# MONITORING YEAR 5 ANNUAL REPORT

## OWL'S DEN MITIGATION SITE

RE: Owl's Den Mitigation Site-Year 5 Monitoring Report  
Final Submittal for DMS  
Contract Number 005150, DMS# 95808  
Catawba River Basin – CU# 03050102; Lincoln County, NC  
*Providing mitigation for CU#03050103 (Catawba ESA)*

Wildlands Engineering, Inc. (Wildlands) has reviewed the Division of Mitigation Services (DMS) comments and observations from the Owl's Den Mitigation Site Draft Year 5 Monitoring Report. The report text has been revised for the final draft to reflect the most current condition of the site. The following are your comments and observations from the report and are noted in **Bold**. Wildlands' response to those comments are noted in *Italics*.

**Table 1. Project Components and Mitigation Credits**

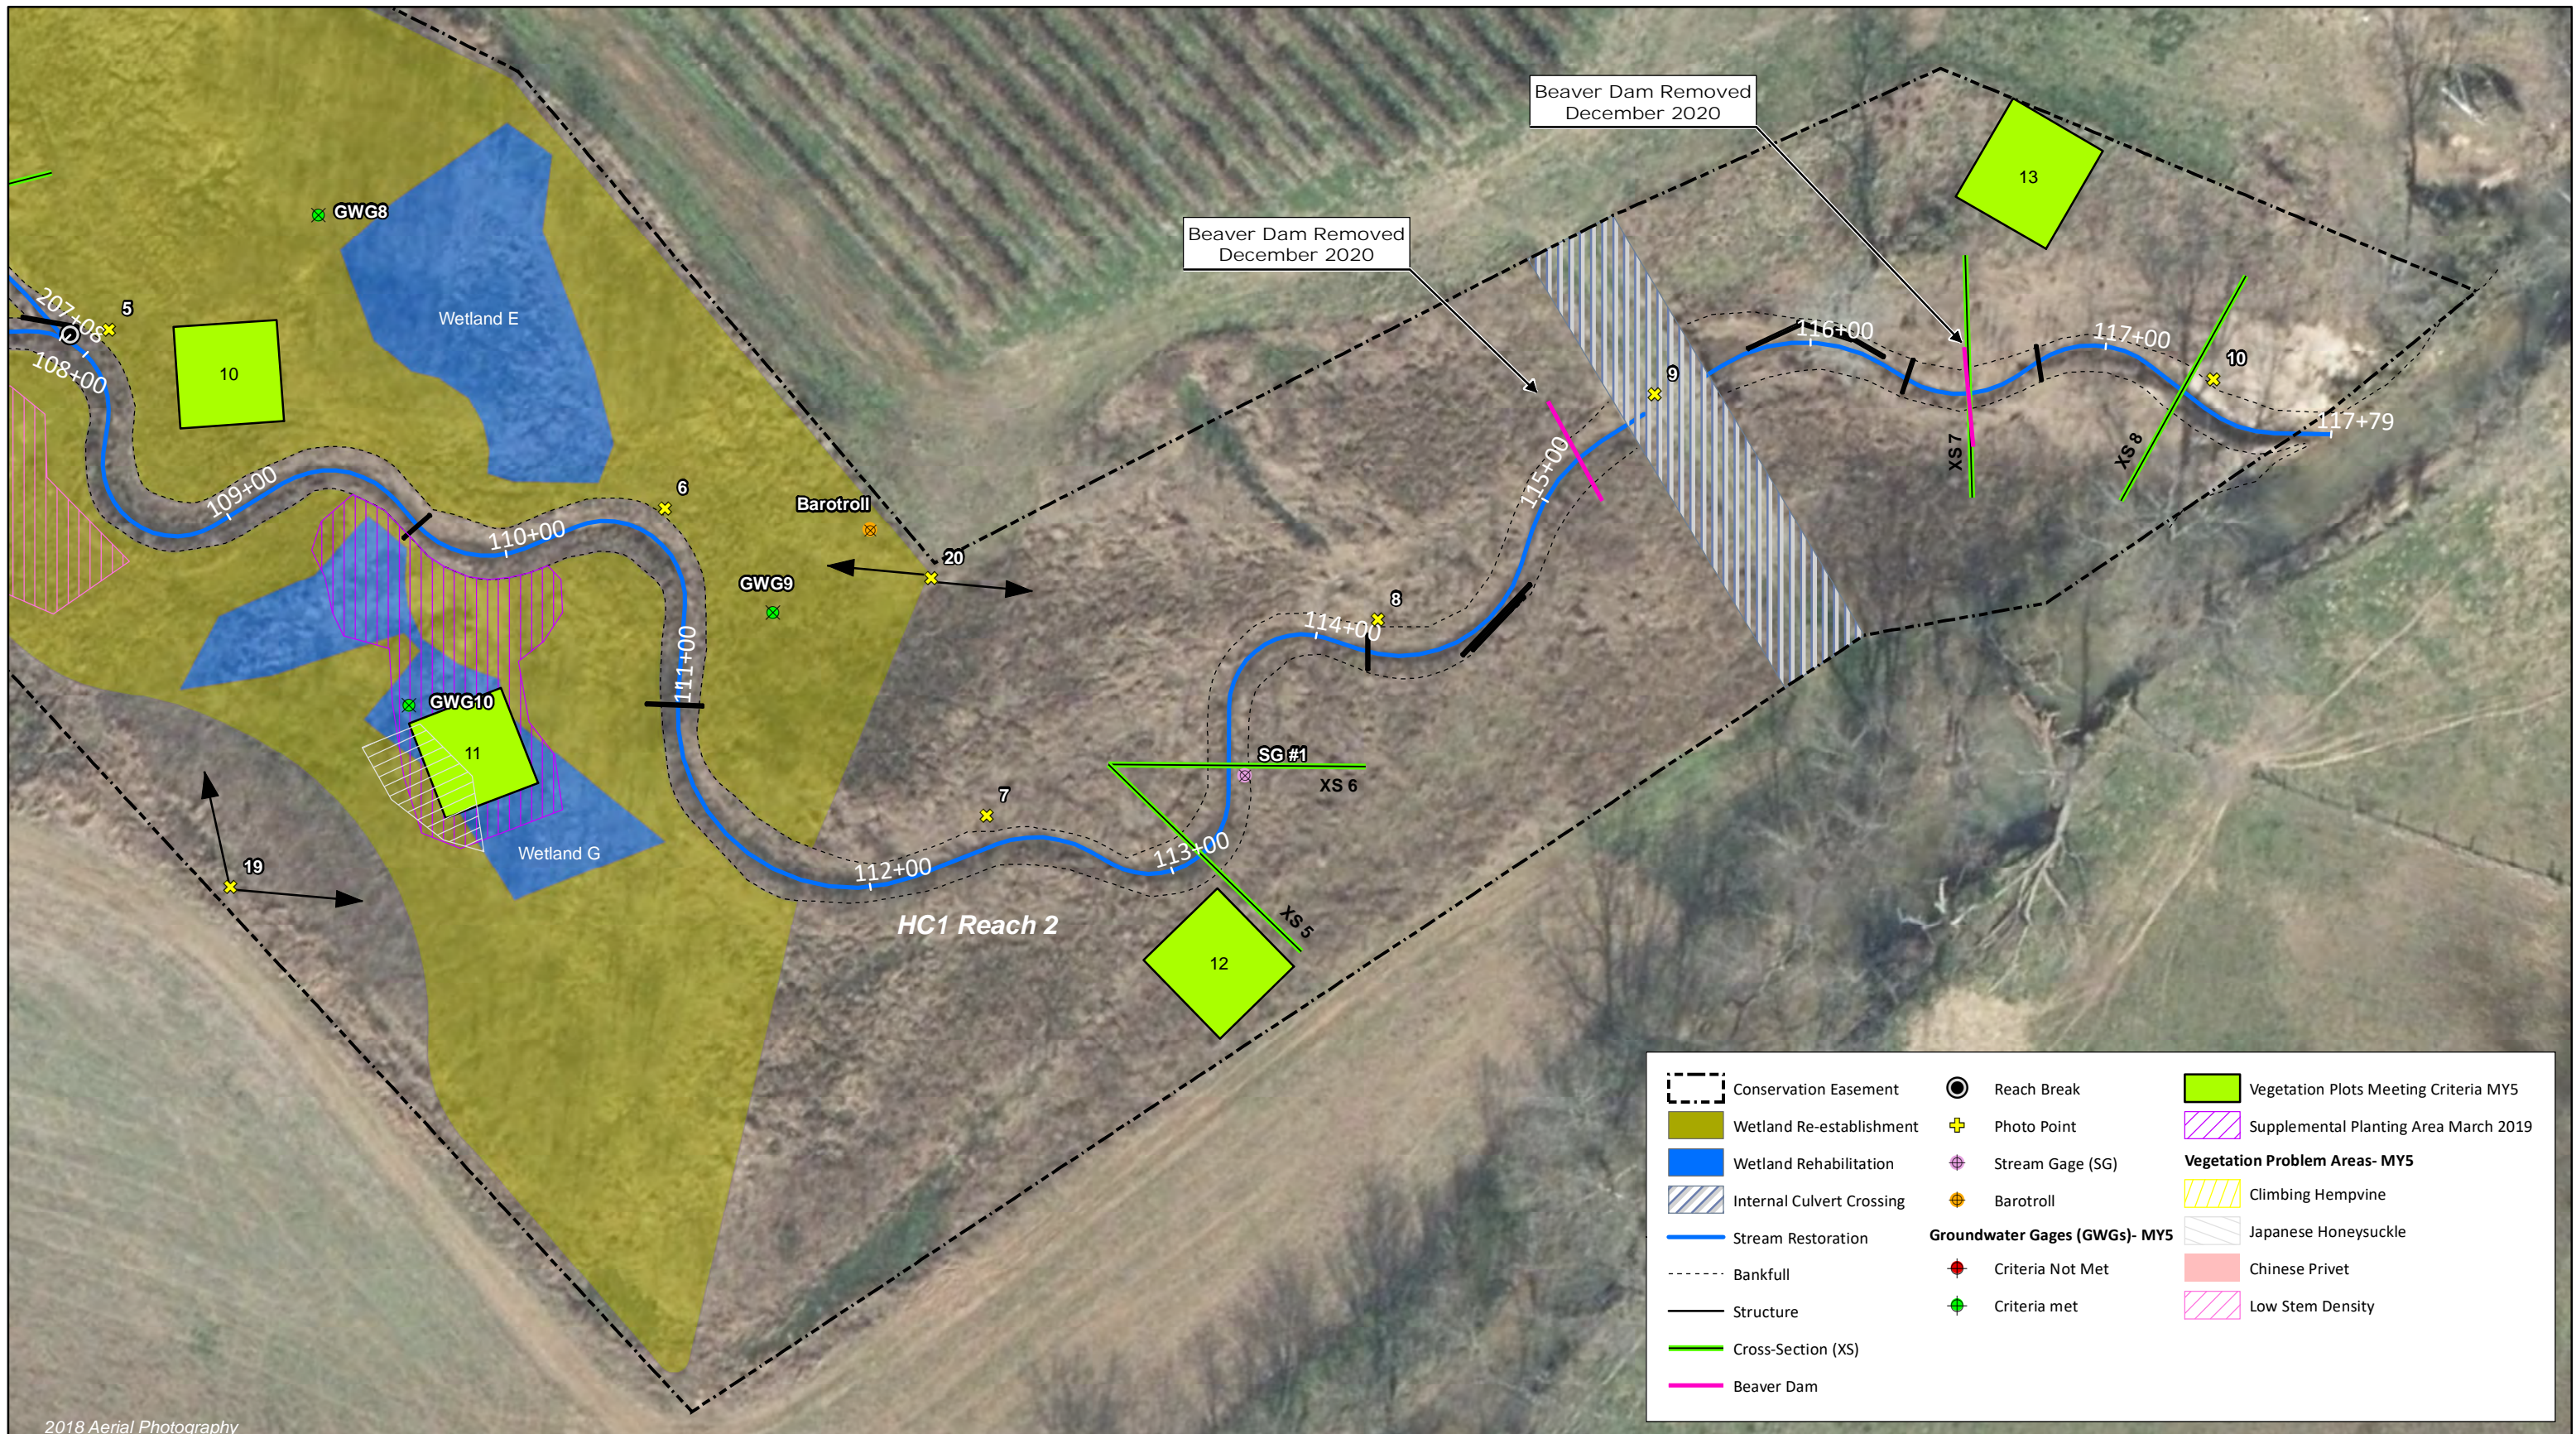
**DMS Comment: Section 1.2.5 - Areas of Concern/Adaptive Management Plan: Please update this section to indicate when these dams were removed and beaver trapped or provide a scheduled removal/ trapping date/s. DMS recommends removing beaver and beaver dams as soon as possible to avoid potential irregular monitoring data, project damage and additional project maintenance.**

*Wildlands Response: The report and figures have been updated to reflect that the dams were removed in early December of 2020. Wildlands is currently monitoring for continued beaver activity and will address in Q1 of MY6, if needed.*

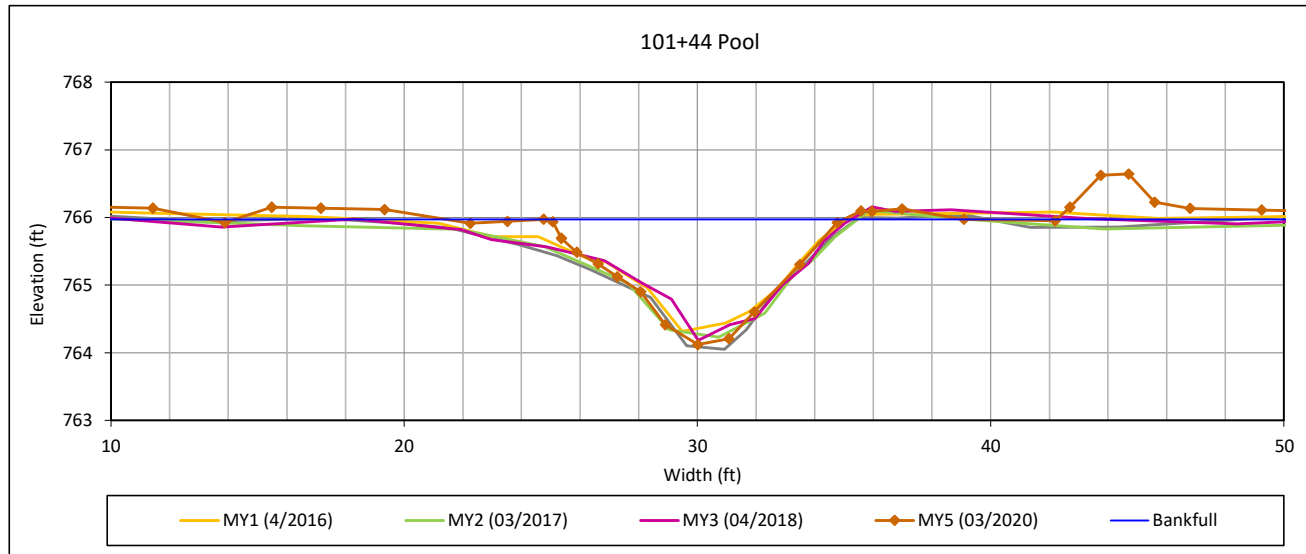
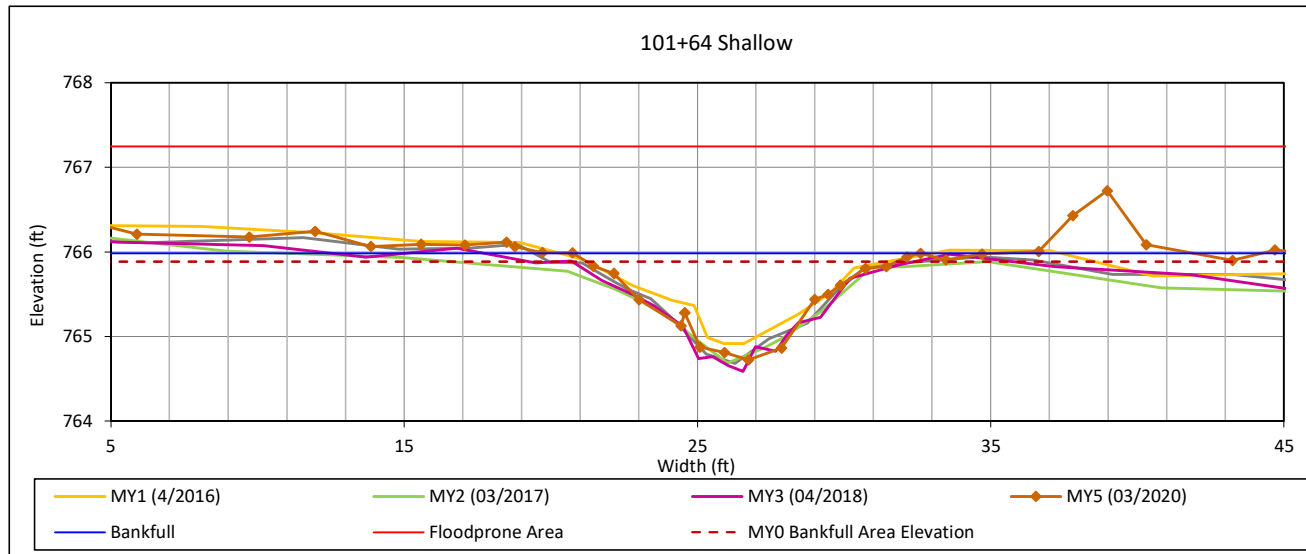
**DMS Comment: Cross Section 1 & Cross Section 2:** The photographs for these cross sections show what appears to be flooding or back water with no defined bed and bank; however, no beaver dams were reported along this reach. Please explain and update the report text if necessary.

*Wildlands Response: There was a beaver dam present on the stream channel downstream of XS2 during the time of survey. This contributed to the floodplain inundation present in the cross-section photos. Soon after survey, the dam was cleared from the channel. The dam was not present on the channel during the November 2020 Site walk, which is why it was not included on the CCPV maps. The dam has been added to the CCPV maps for reference and text with a note that it was removed in March 2020.*
